Midway City Council
15 February 2022
Regular Meeting

Resolution 2022-07 /
Watts Remund Farms
Master Plan Agreement
Second Amendment

CITY COUNCIL MEETING STAFF REPORT

NAME OF PROJECT: Watts Remund Farms Phase 4 PUD

Exhibit C

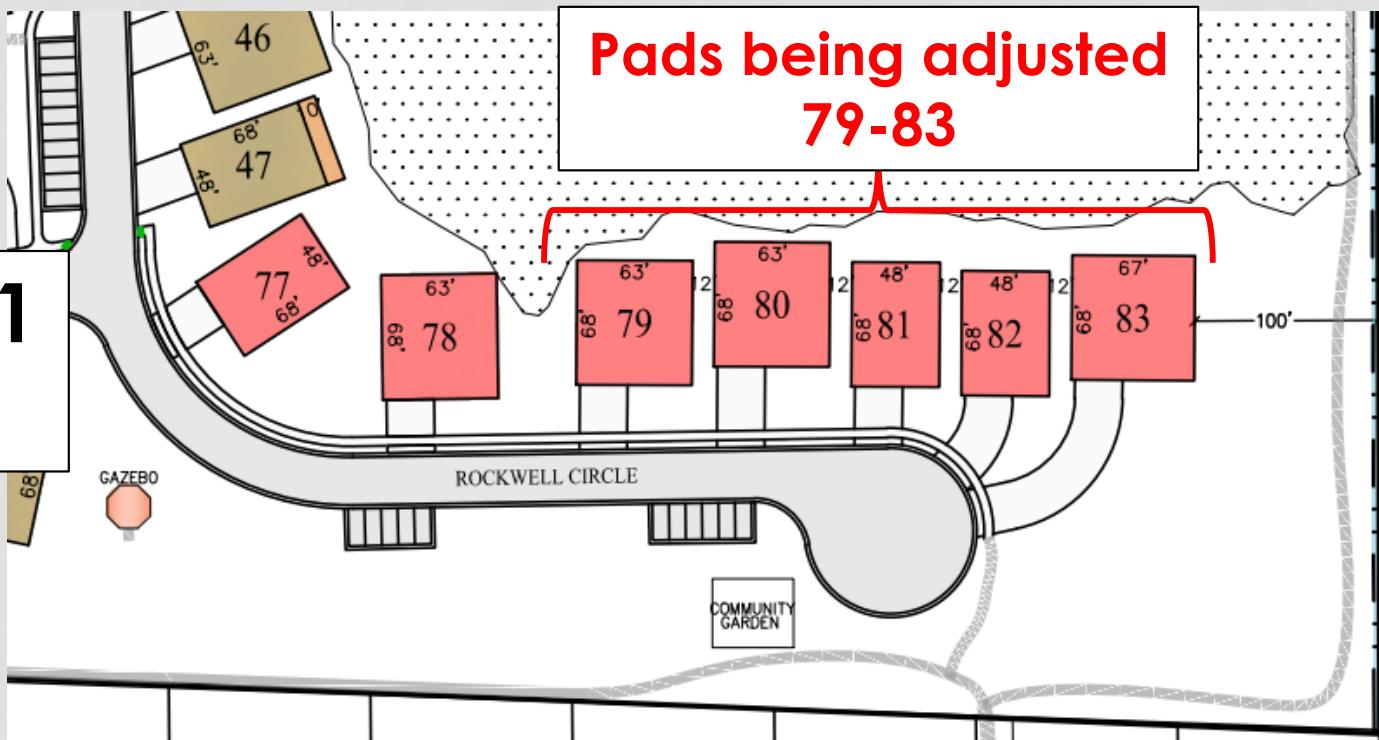
Berg Engineering, agent for Midway Springs LLC Series II, is proposing a Master Plan amendment to the Remund Farms Planned Unit Development (PUD) phase 4 which would update the existing master plan for the phase. A previous master plan amendment was approved for the whole development on October 1, 2019. The applicant's proposed changes are to adjust the building footprints for five of the seven building pads in the phase, to allow for the construction of homes that are similar in size to those that are currently being built in the earlier phases. Some of the footprints would expand (depth and width), while some would be reduced.

Sensitive lands protection – The proposed amendment would allow some building footprints to encroach closer to the delineated wetlands. The land use code precludes surface grading within 25' of wetlands unless approved by the City Engineer. In the current masterplan, there are a few building footprints that abut wetlands. In the proposed amended master plan, some units would encroach further into the 25' wetland buffer, with some directly abutting the wetlands. No footprints encroach into the delineated wetlands. Wes Johnson, the city engineer, has indicated that he is ok with the proposed footprints with the understanding that the applicant will survey the boundaries of the wetlands and then install temporary construction fencing when the site improvements begin for both phases as well as when homes are constructed in both phases. Over excavating into the wetlands is not allowed.

Setbacks to neighboring properties – The proposed adjustments to the building pads create an overall enlargement of the pads. The current land use code for PUDs requires building setbacks from the peripheral boundary to be a minimum of 60'. This project is vested under a previous code requirement that allowed for a 30' building setback from the peripheral boundary. In phase 4, it appears that the setbacks to the property boundaries to the east and south remain the same.

- The proposed master plan appears to meet the requirements of the code
- The building pads for five of the seven units will change in size creating an overall increase in building square footage and reduction in open space
- The setbacks from the proposed building pads to the peripheral boundaries will remain the same
- One public trail will be paved and the funds for the construction of a second trail will be contributed to the general trails fund as part of the subdivision. Both trails will benefit members of the community
- Amending the master plan is discretionary and the city is under no obligation to approve the proposal even if it complies with the land use code
- Some of the proposed building pads will encroach closer to the delineated wetland

Exhibit F

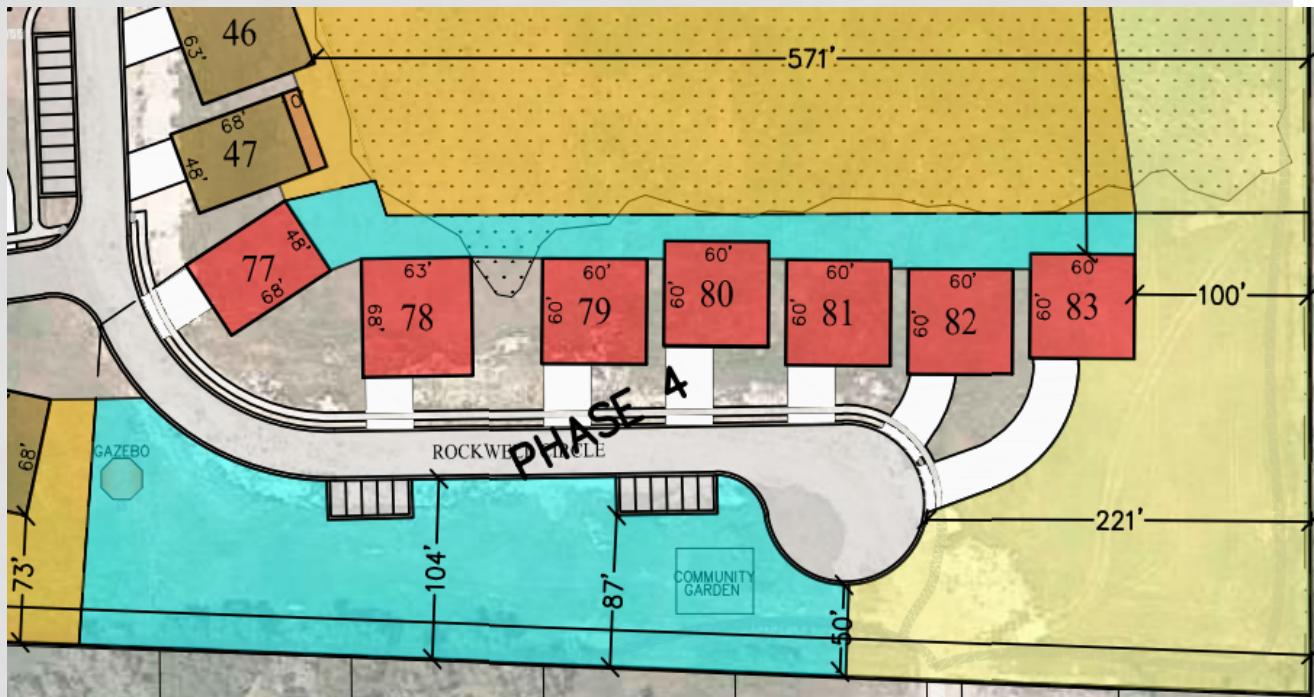
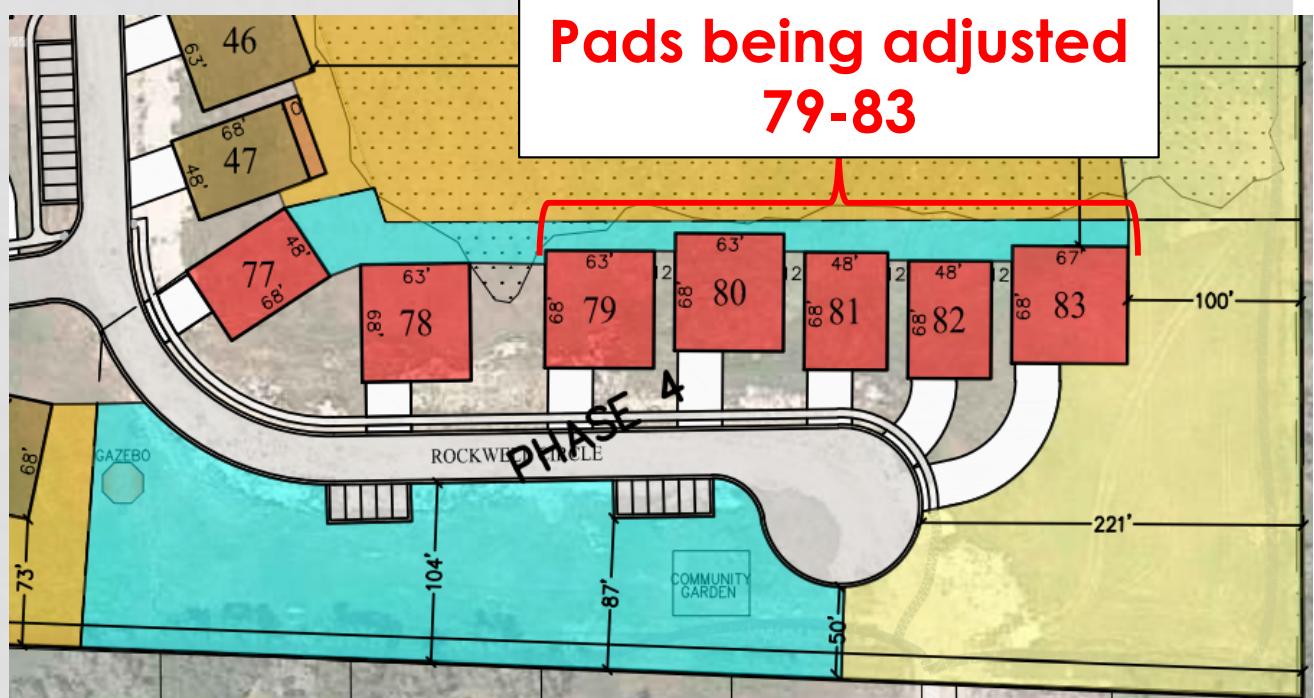
Open Space – The code requires that each phase to have sufficient open space to comply with the requirements of the code. For example, phase I must have at least 50% open space for that particular phase. If phase I has 75% open space, then phase II only needs to have 25% open space if both phases are equal in acreage. Although the applicant is enlarging some footprints and decreasing others, the overall open space for the project decreases by approximately 5,227 SF, or 0.12 acres due to the proposed adjustments. The proposed adjustments will decrease the overall open space percentage from 54.24% to 54.07 %. The applicant has provided an amended open space plan and the proposed plan appears to comply with the 50% open space per phase requirement for the development.

Overall open space decrease of 0.12 acres (0.17%)

Setbacks to property
lines remain the same

Exhibit H

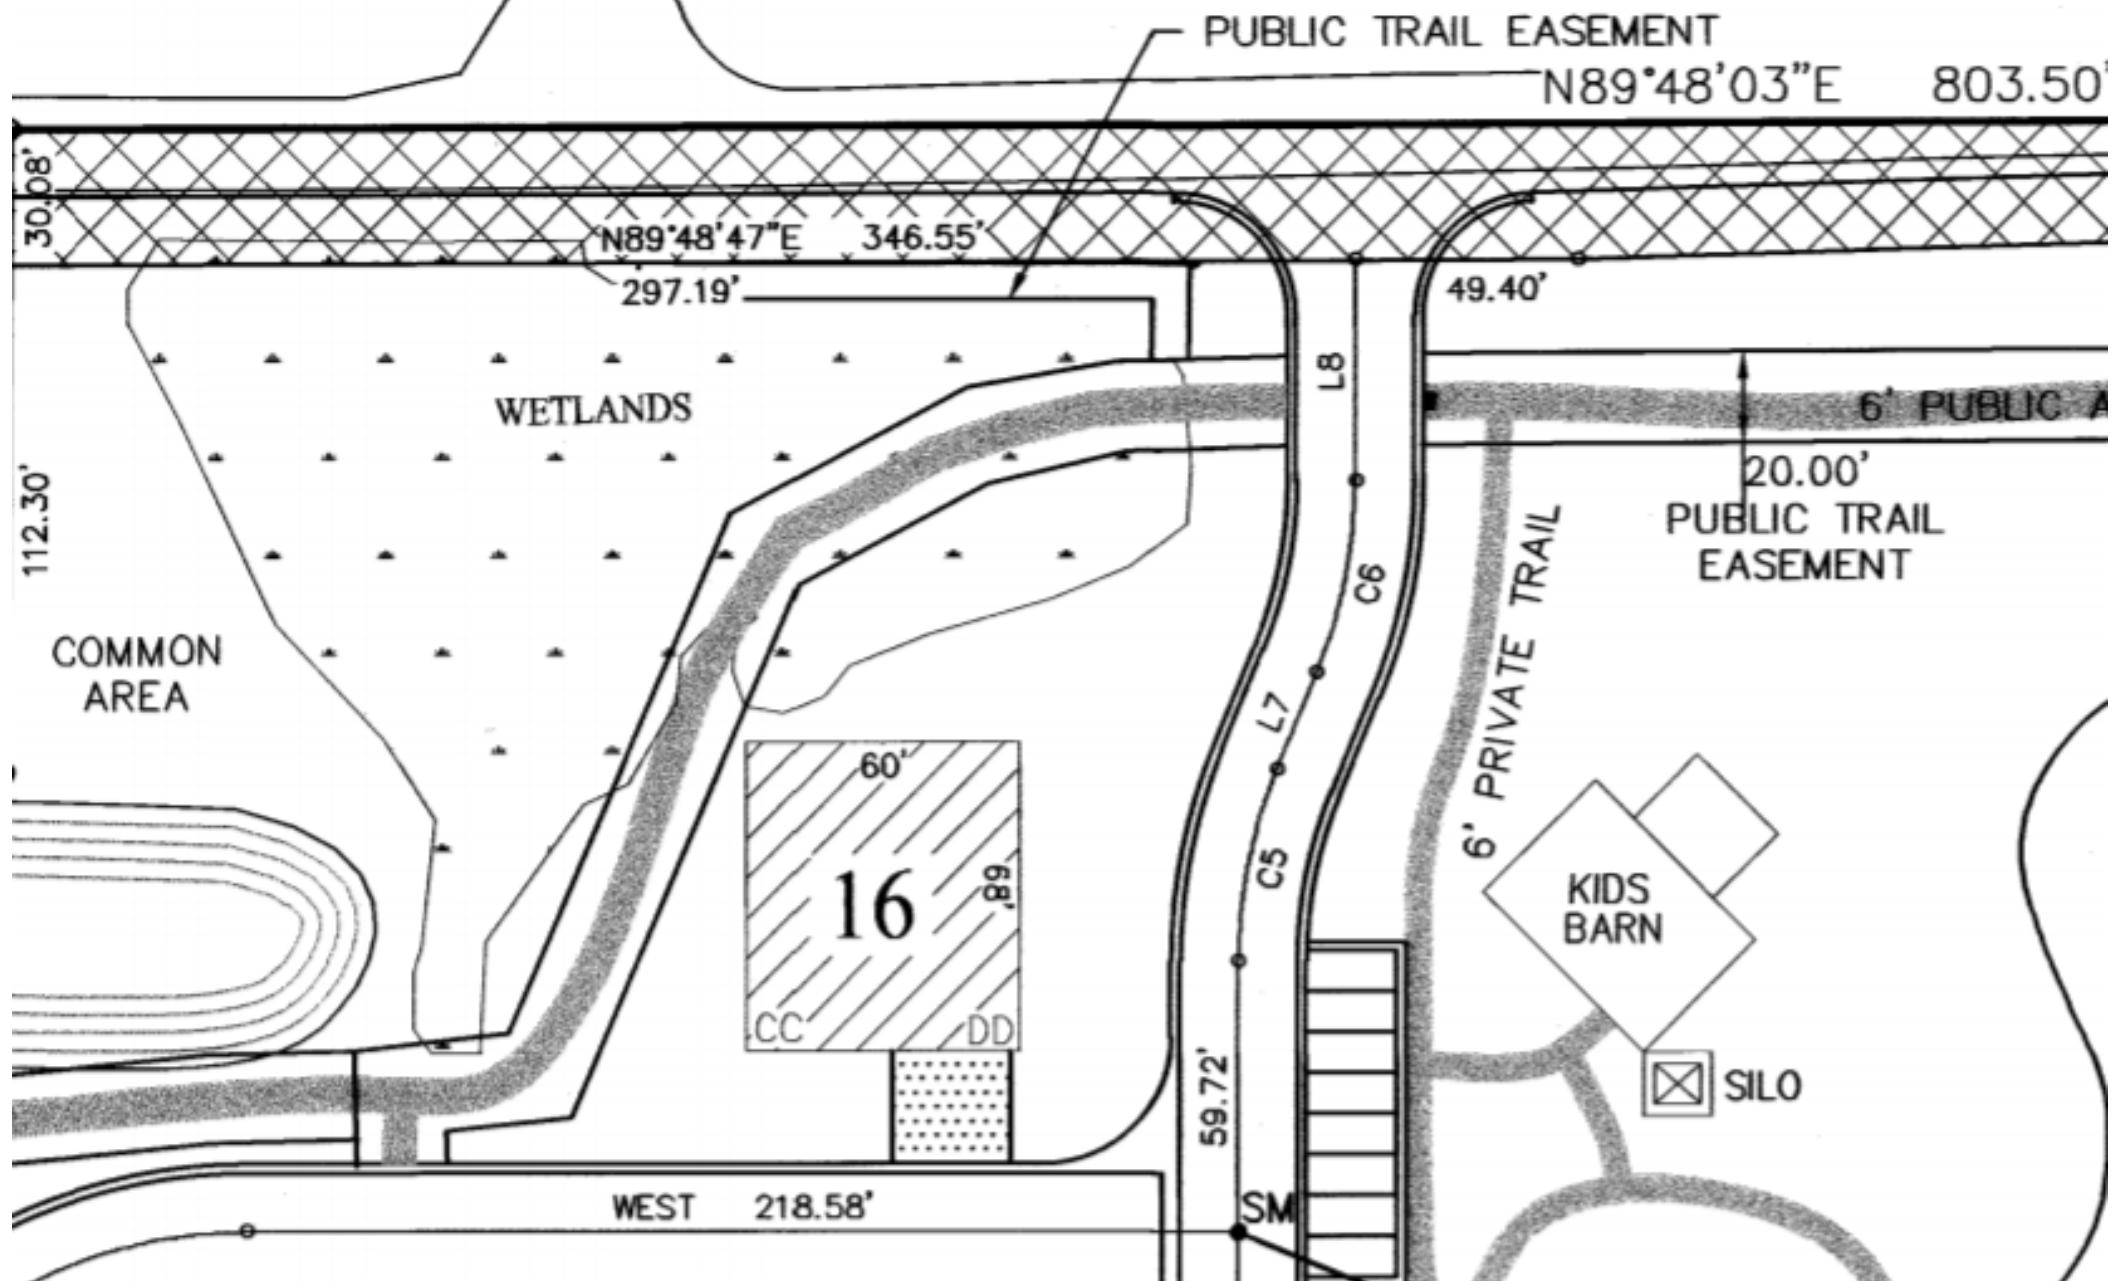
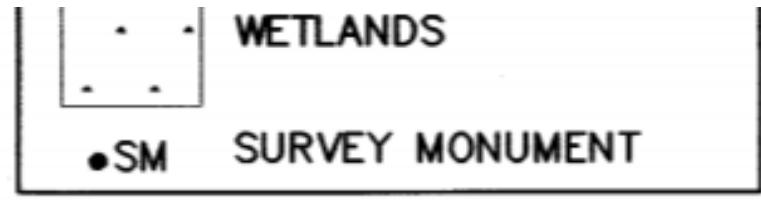
- The second condition would require the applicant to contribute the costs associated with paving an 8' onsite trail to the general trail fund so that trail can be built with a future trail project. This small section will allow people to safely connect from the existing public trail in Remund Farms to the future trail that will run north along 200 East. The trail is onsite, and the easement was dedicated with the Phase 1 plat, but the trail has not been constructed and the funds to do so were not previously required.

- The applicant could also build a trail connecting to 200 East on 600 North.
- Partial results had been received from the water studies.
- The project setbacks were grandfathered from a previous code.

2. The applicant will be required to contribute the funds associated with installing the 8' asphalt trail from Farm Hill Lane to 200 East to the general trails fund. The funds will be used when the trail is completed in the future as part of a larger improvement project.
